17 July, 2002
LTR-NRC-02-36

SUBJECT: WESTINGHOUSE RESPONSE TO NRC RAIs REGARDING WCAP-15689-P
[ENCLOSURE 1-P CONTAINS WESTINGHOUSE PROPRIETARY CLASS 2 INFORMATION]

WESTINGHOUSE NON-PROPRIETARY RESPONSE TO NRC RAIs REGARDING WCAP-15689-P

With respect to WCAP-15689-NP, Page 6, Section 2.4, 2nd paragraph and Figure 2:

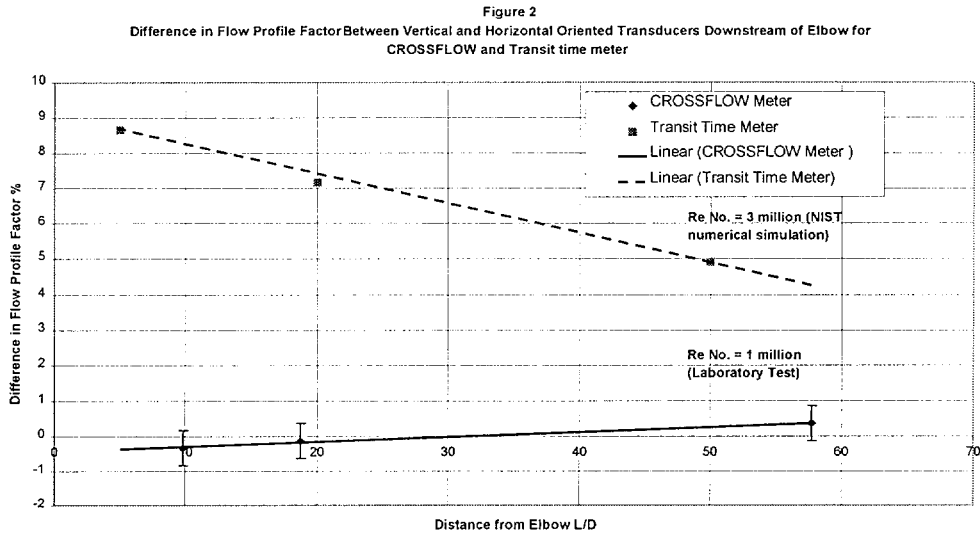
This figure is marked proprietary in its entirety, however, the corresponding discussion of the figure is non-proprietary. Please provide a non-proprietary version of the figure, if possible, to facilitate writing of the NRC’s ER-262 evaluation report which will be in the public domain. Additionally, the lines drawn on the figure are indistinguishable from one another since the figure is not in color. Use of different line types would facilitate understanding the figural presentation.

The proprietary classification of Figure 2 has been removed so that the figure can be referenced in the NRC evaluation report. To facilitate the presentation, the sensitivity curve for the transit-time meter has been replaced by a dashed line to delineate it from the corresponding curve for the CROSSFLOW meter. The revised figure is shown below and has been downgraded from its former proprietary status to facilitate NRC use.
